SUBMITTAL REVIEW

CLIENT NAME: Vails Gate Fire Department
PROJECT TITLE: Vails Gate FD - New Firehouse
SUBMITTAL No.: 224000-3 **H2M PROJECT No.:** VGFD2001
SUBMITTAL NAME: Plumbing Fixtures Phase 2 Trench Drain PD

6-3/4 [171] WIDE REVEAL TRENCH DRAIN SYSTEM WITH HEAVY-DUTY FRAME ASSEMBLY

Z886-HD

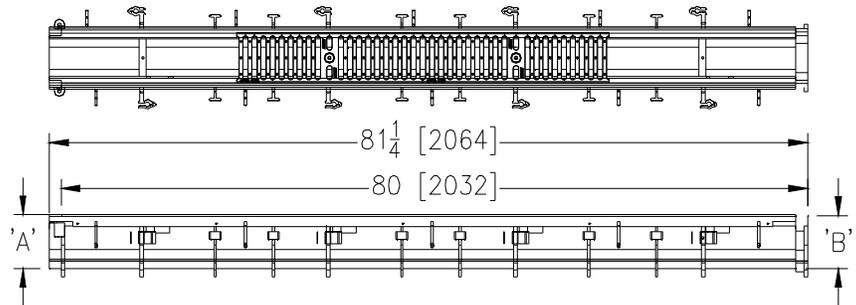
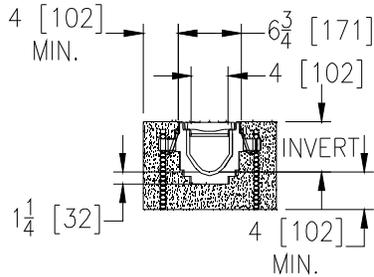
the 4- 32ft lengths would be 4.8 sections each
the 1- 52ft length would be 7.8 sections
